# UNITED STATES PATENT AND TRADEMARK OFFICE

APPLICATION NO.	FILING DATE	FIRST NAMED INVENTOR	ATTORNEY DOCKET NO.	CONFIRMATION NO.
10/670,787	09/26/2003	Seung Jun Han	8733.597.01	4358
30827	7590	12/28/2005	EXAMINER	
MCKENNA LONG & ALDRIDGE LLP 1900 K STREET, NW WASHINGTON, DC 20006				HAN, JASON
ART UNIT		PAPER NUMBER		
		2875

<b>Office Action Summary</b>	<b>Application No.</b>	<b>Applicant(s)</b>
	10/670,787	HAN ET AL.
	<b>Examiner</b>	<b>Art Unit</b>
	Jason M. Han	2875

**DETAILED ACTION*****Response to Arguments***

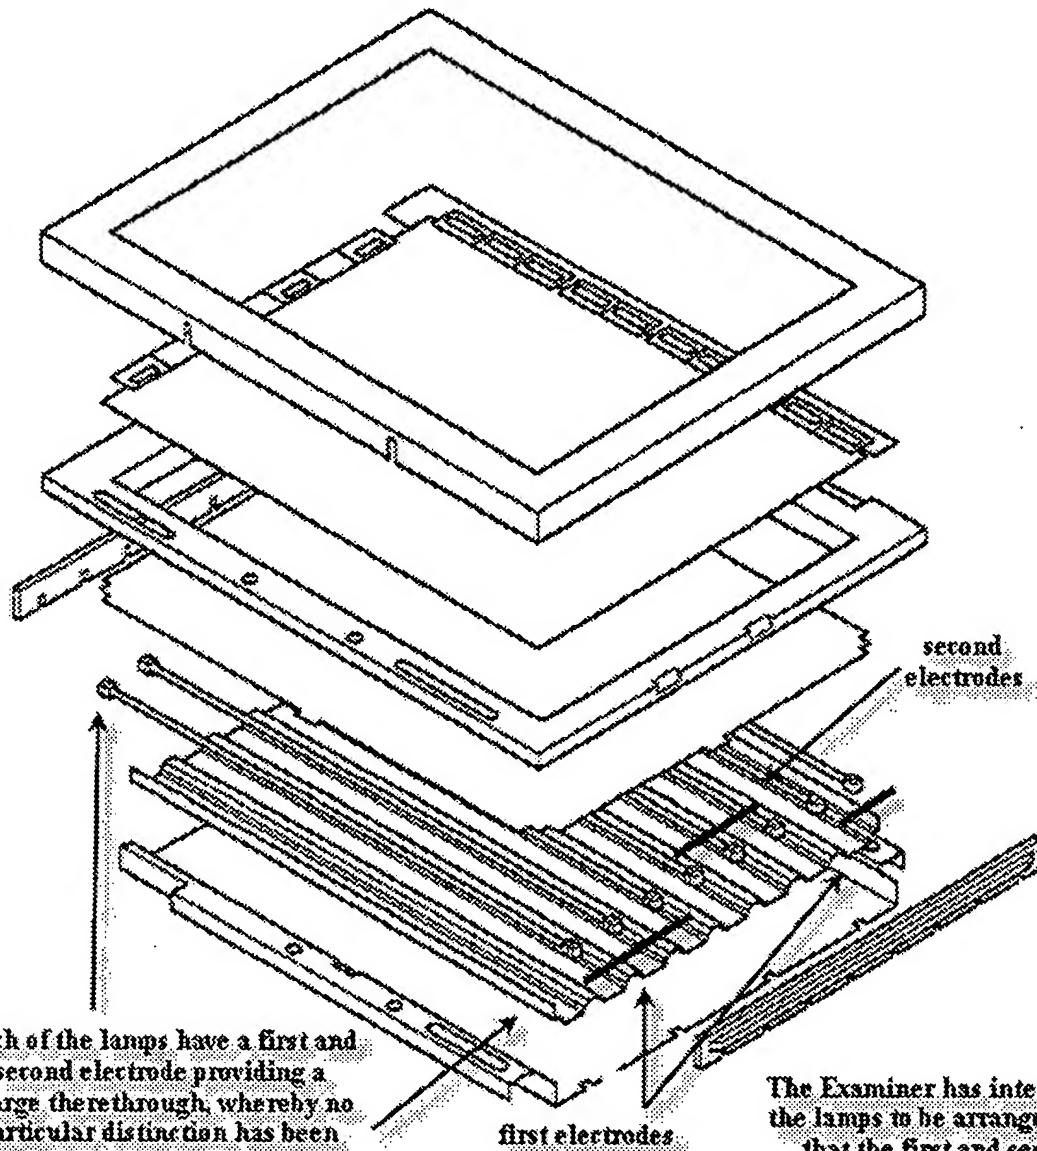
1. Applicant's arguments filed November 14, 2005 have been fully considered but they are not persuasive. The prior art of Itoh (U.S. Publication2002/0030993) remains commensurate to the scope of the claims as stated by the Applicant and broadly interpreted by the Examiner [MPEP 2111]. Below is a recapitulation and elucidation of the Examiner's interpretation and how each of the structural limitations has been satisfied, which the Applicant disputes. It should be noted that the claim language at present is insufficient in structure to render a definite invention over the prior art of record, whereby no distinction has been made between the first and second electrodes (e.g., a high pressure electrode and lower pressure electrode as supported by the specification).

- A lamp housing [Figure 1: (4)]; and
- A plurality of lamps [Figure 1: (1)] respectively having a first electrode and a second electrode (inherent as shown in the drawing below) and arranged in the lamp housing so that the first and the second electrodes are alternately disposed in one side of the lamp housing (structurally insufficient to read over a broad interpretation by the Examiner as shown in the drawing below).

Each of the lamps have a first and second electrode providing a charge therethrough, whereby no particular distinction has been made by the Applicant to differentiate between the two.

The Examiner has interpreted the lamps to be arranged such that the first and second electrodes are alternately arranged by a positive integer more than 2 in one side of the lamp housing.
